EX. 1028

CROSS SECTION A-A' COSON RESIDENCE MERCER ISLAND, WASHINGTON

FIGURE 3

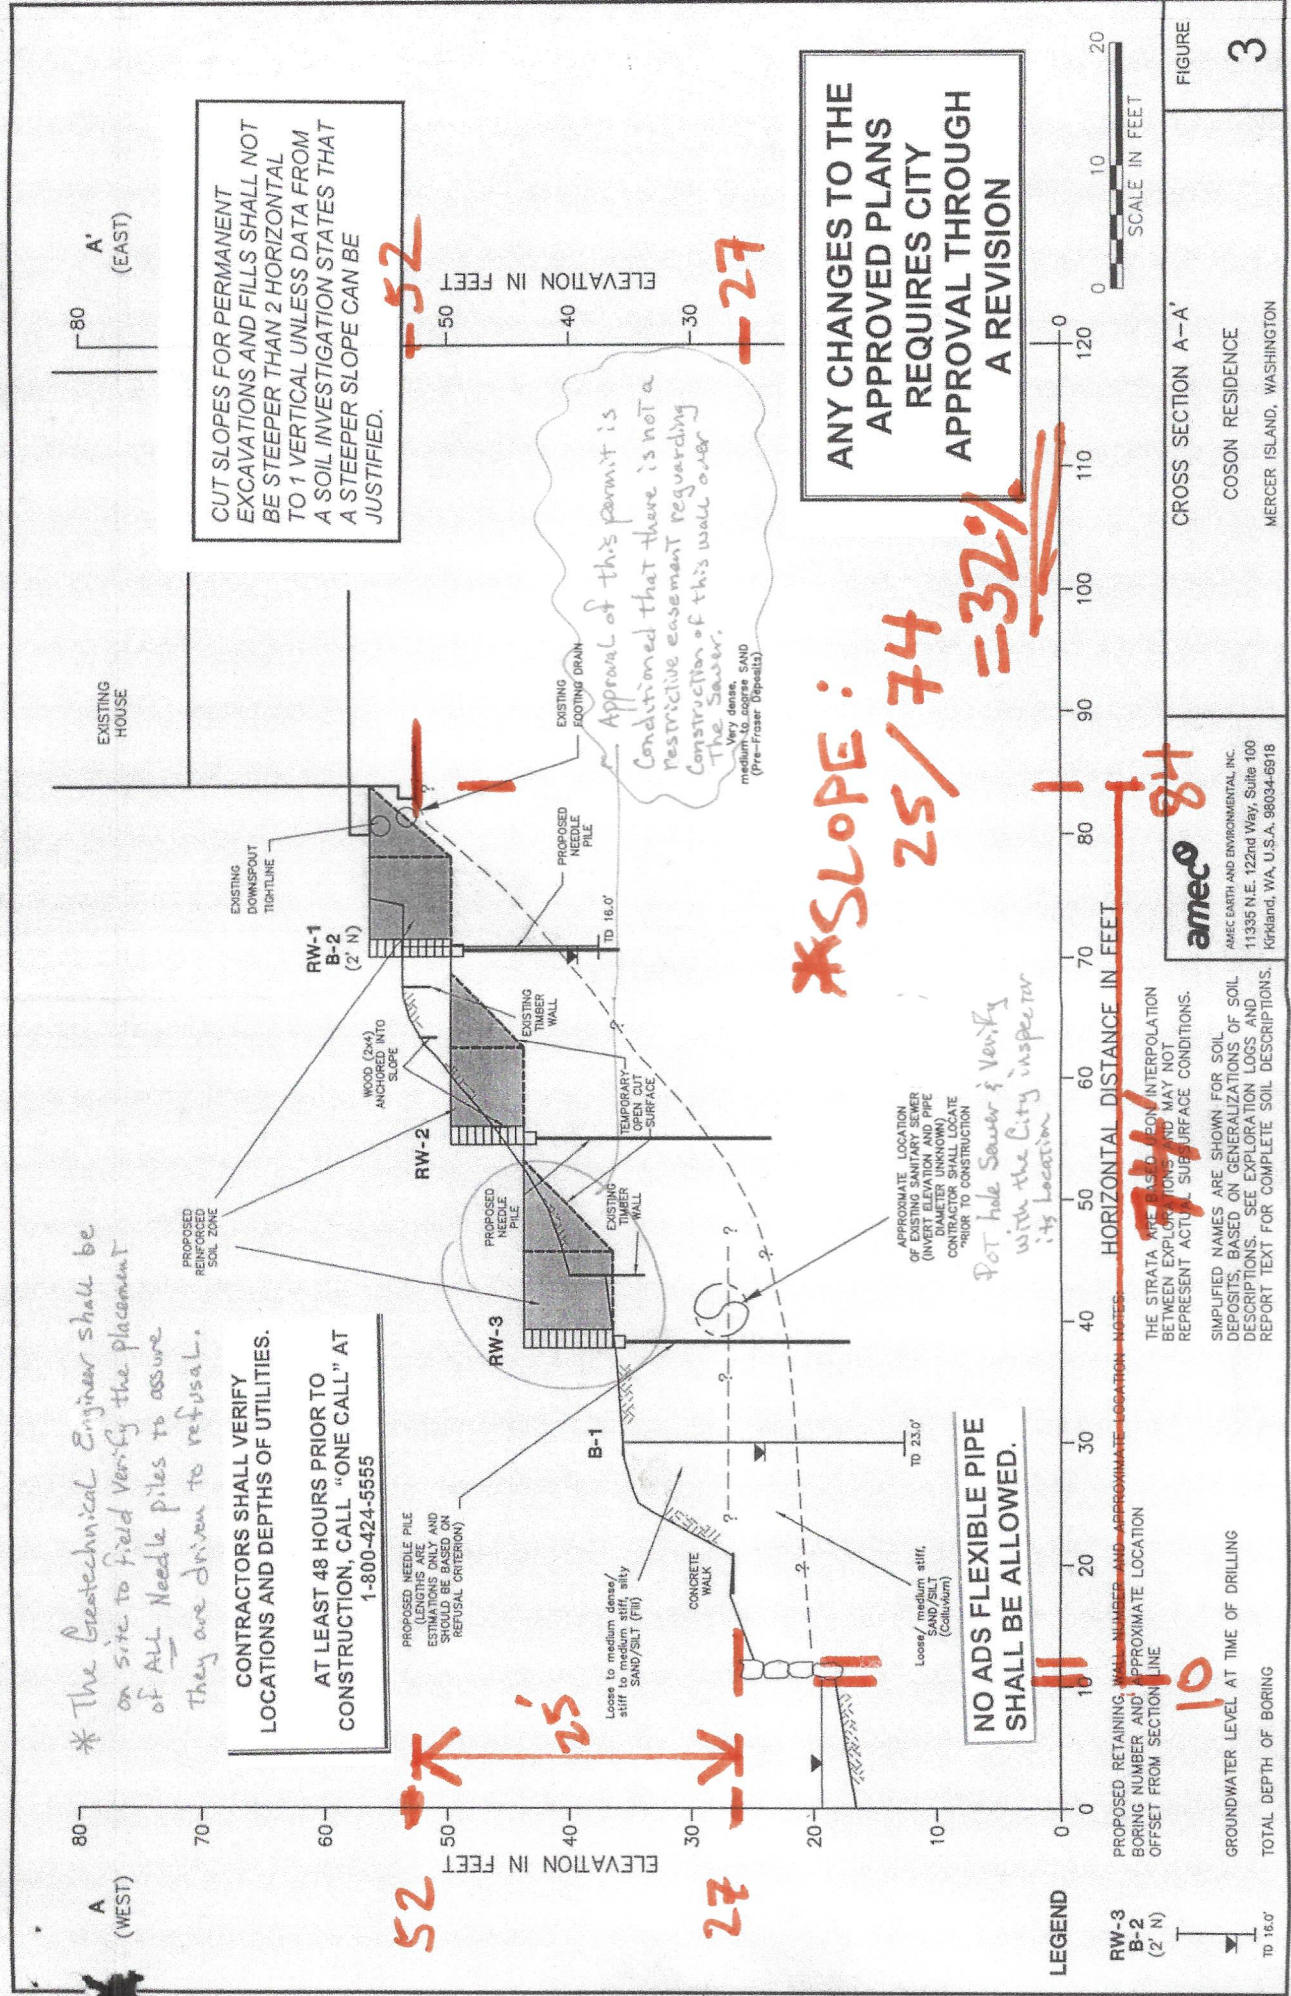
* The Geotechnical Engineer shall be on site to field verify the placement of ALL Needle piles to assure they are driven to refusal.

ANY CHANGES TO THE APPROVED PLANS REQUIRES CITY APPROVAL THROUGH A REVISION

Approval of this permit is conditioned that there is not a restrictive easement regarding construction of this wall over the sewer. Very dense, medium to coarse SAND (Pre-Fraser Deposits)

Pot hole Sewer & verify with the City inspector by location
